**Explanation of Significant Differences
Landfill Cap Redesign
IR Site 1, Tidal Area Landfill**

**Naval Weapons Station Seal Beach
Detachment Concord
Concord, California**

April 25, 2008

A	Navy Responses to Regulatory Agency Comments on the Draft Technical Memorandum Landfill Cover Redesign, IR Site 1, Tidal Area Landfill
B	Revised Landfill Cap Plans
C	Revised Construction Specifications
D	Settlement Evaluation
E	Slope Stability Evaluation
F	Supplemental ARARs Evaluation

FIGURE 6
PRELIMINARY SITE 1 LANDFILL CAP PROJECT SCHEDULE
Naval Weapons Station Seal Beach Detachment Concord

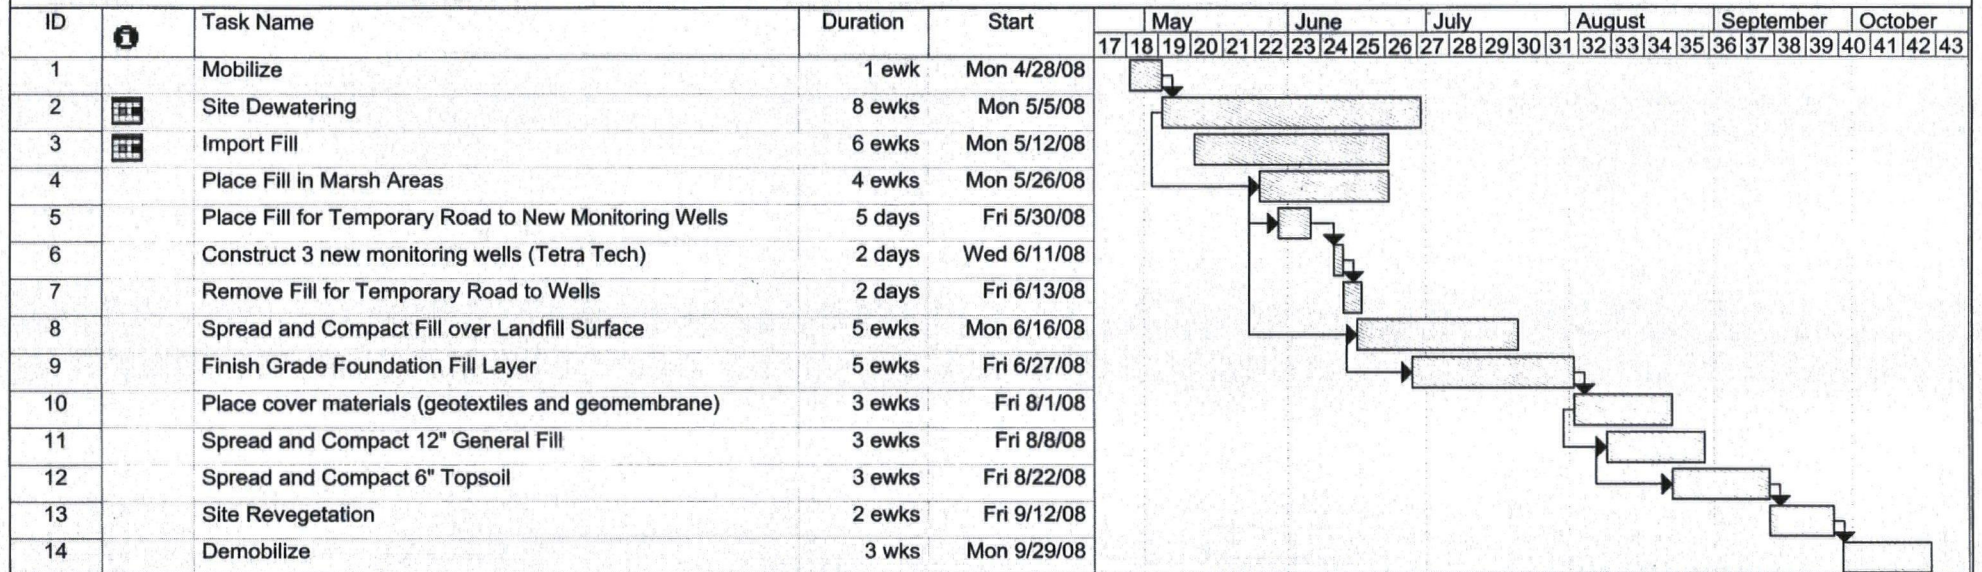
1. **Comment:** **Schedule:** We request a revised schedule for the completion of the landfill cap.

Response: A revised schedule is included in the ESD document as Figure 6.

SIZE D
IF SHEET IS LESS
THAN 22" X 34"
IT IS A REDUCED
PRINT
SCALE REDUCED
ACCORDINGLY
CODE IDENT. NO.
00000
PROJECT LOCATION
CONCORD, CALIFORNIA
CONSTR. CONTR. NO.
000-00-X-000
SPECIFICATION
00-00-0000
NAVFAC DWG. NO.
DS 000.0000
DWG. NO.
C-100
SHEET 5 OF 7

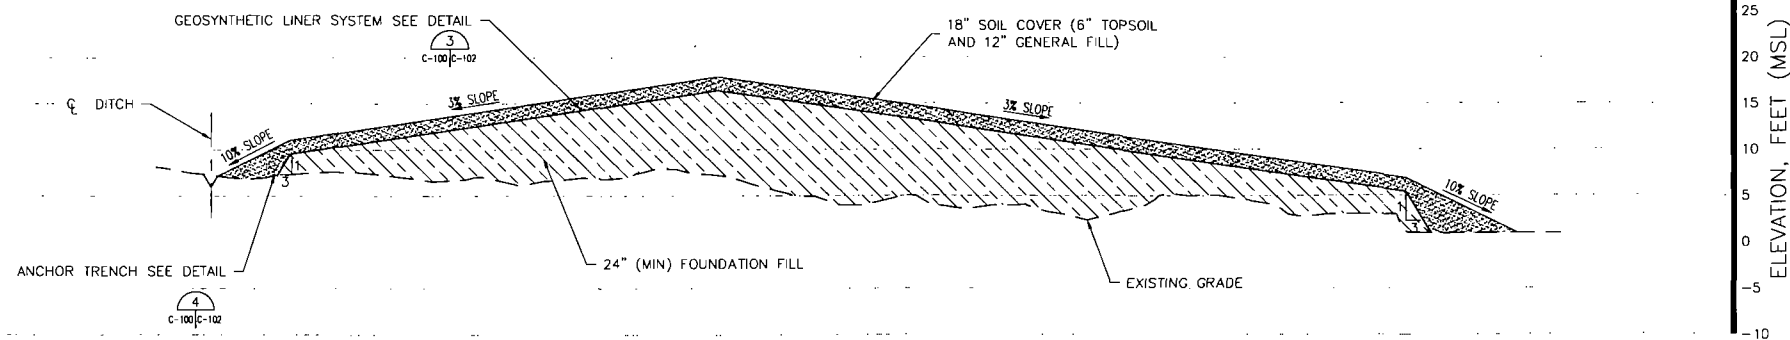
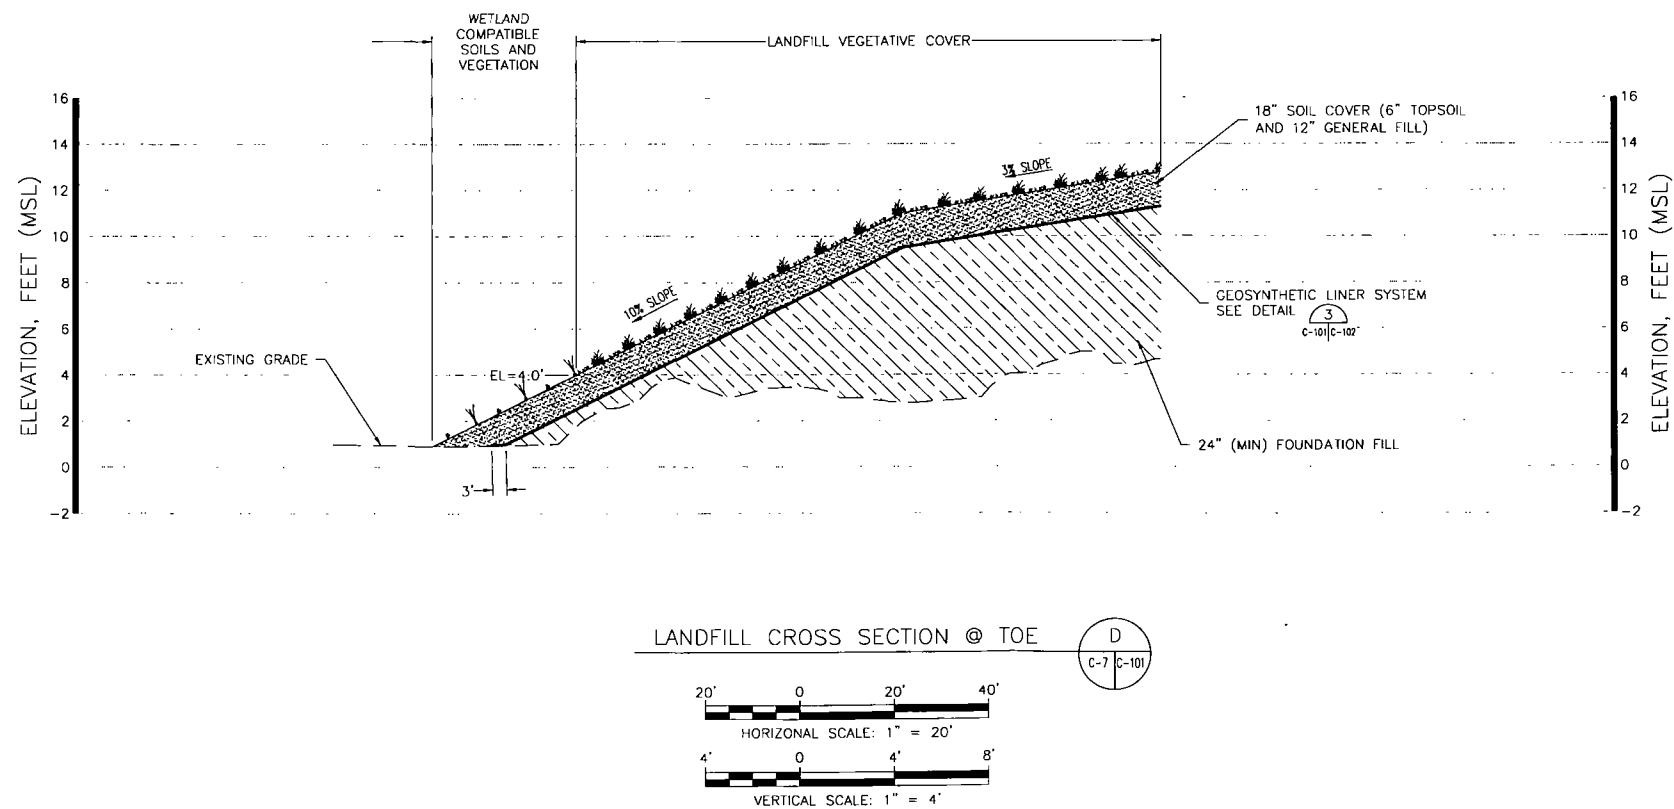
4. **Comment** Section 4.5, Protectiveness of the Remedy, Page 15: One potential long-term concern that is not addressed in this section or in the design is the effect of sea level rise. As shown in Drawings C-100 and C-101, the toe of the south and west sides of the soil cover will be approximately 1 foot above sea level. The north and east side toes will be approximately 5 to 6 feet above sea level. According the U.S. Geological Survey Fact Sheet 175-99 (<http://pubs.usgs.gov/fs/1999/fs175-99/>) the Fort Point gauging station next to the Golden Gate Bridge has recorded sea level increases averaging 0.04 to 0.08 inches per year since 1900. This rate may accelerate during the next 100 years. In addition to rising sea level, abnormally high tides are not unknown in the San Francisco Bay region. The same USGS Fact Sheet notes the occurrence of high tide at 5 feet above mean sea level on February 3, 1998, due to the El Nino that year. Although the extent of sea level rise is uncertain, extreme high tides accompanied by wind storms and heavy wave action can be confidently predicted to occur several times during the 30 to 50 year design life of the cover proposed for the Tidal Area Landfill. Please address the long-term stability of the proposed cover considering sea level rise, and under abnormal high tide (5 ft. AMSL) and wind storm conditions.

Covering the landfill waste with a relatively impermeable synthetic barrier from above combined with the relatively impermeable natural geology from below is intended to provide hydraulic isolation of the waste from the surrounding environment. Because of the hydraulic isolation of the waste, significant groundwater flow is not expected under the cyclic diurnal tide conditions, which will exert only relatively low water pressures. Extreme tides driven by low atmospheric pressure or flooding are of short duration and are also not expected to have significant impact. Sea level rise, although persistent, is gradual and is not expected to result in any significant persistent hydraulic gradient at the site. The groundwater monitoring program is intended to monitor the surrounding area to verify there are no impacts from contaminated leachate. The landfill design accounts for short-term tidal fluctuations, flooding, and the persistent rise in sea level.
